**C L E P A**  
*European Association of  
Automotive Suppliers*

# Rebound head excursion in R129

51<sup>st</sup> Meeting of UN Informal Group on CRS  
6 May 2015

Figure 1  
Arrangement for testing a forward-facing device

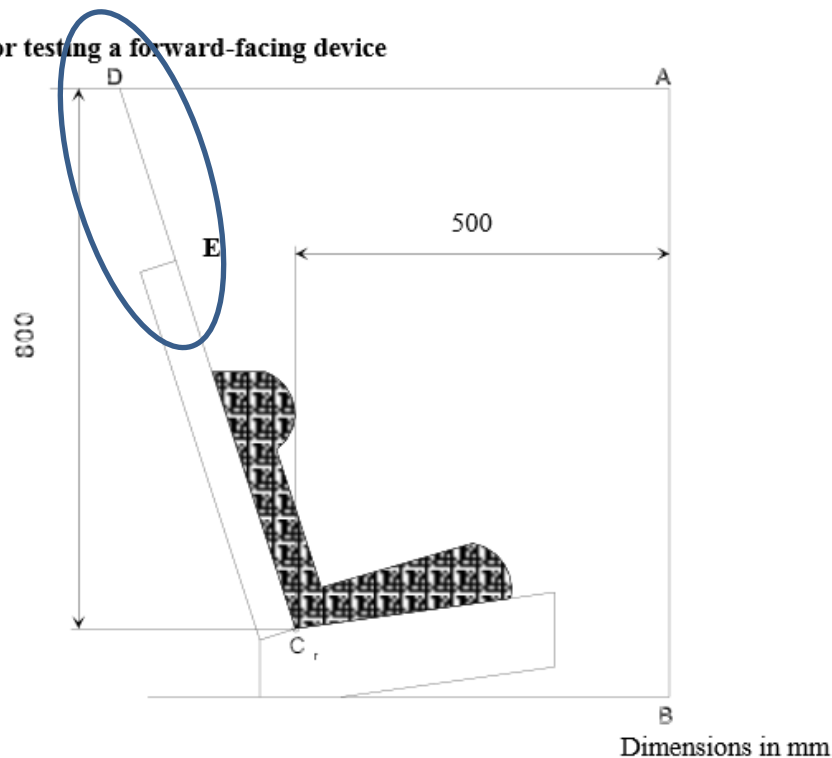
- The minutes of CRS-12 do not refer to any discussion of this issue
- The requirement will be difficult to achieve with larger dummies
- **What real-world safety problem does it address?**
- **Is the Q-Series reliable in rebound?**

- We propose to limit all head excursion requirements to the forward motion of the dummy
  - DE plane removed
  - Vertical head excursion applies in loading phase only
  - Proposal covers all dummies in FF CRS

Head excursion: No part of the head of the dummy shall pass beyond the planes BA, **and** DA ~~and DE~~ as defined in Figure 1 below except for booster seats and booster cushions when using the largest dummy Q10 where the value in relation to the DA plane is 840 mm and the value in relation to the BA plane is 550 mm. **This shall be judged up to the point of peak forward horizontal head excursion** ~~up to 300 ms or the moment that the dummy has come to a definitive standstill—whatever occurs first.~~

Figure 1

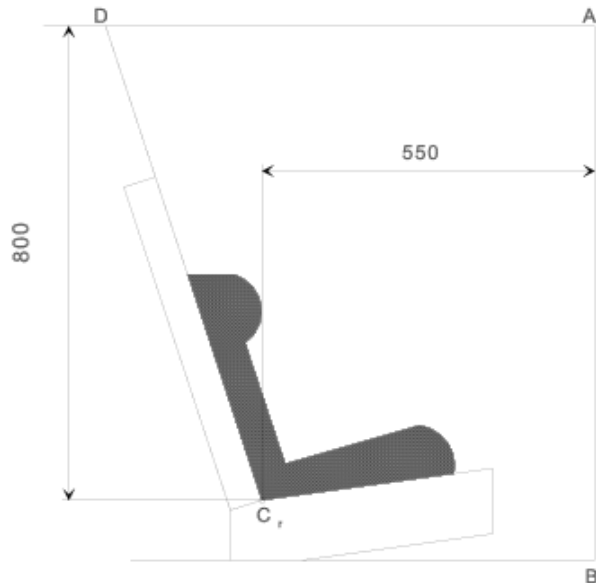
Head excursion: no part of the head of the manikin shall not pass beyond the planes BA, and DA and DE as defined in Figure 1 below. This shall be judged up to 300 ms or the moment that the manikin has come to a definitive standstill whatever occurs first.

*Remark: as is the case with rearward facing child restraints, the point E being the top of the seat back of the R.44 seat should also be defined here.*

*Furthermore, because it concerns ISOFIX child restraints, the forward excursion limit shall have to be changed from 550 mm to 500 mm.*

*Finally, the 800 mm vertical limit shall have to be connected to only testing with Q0, Q1, Q1.5, Q3 and Q6, whilst for testing with Q10 a vertical limit of 840 mm will be used.*
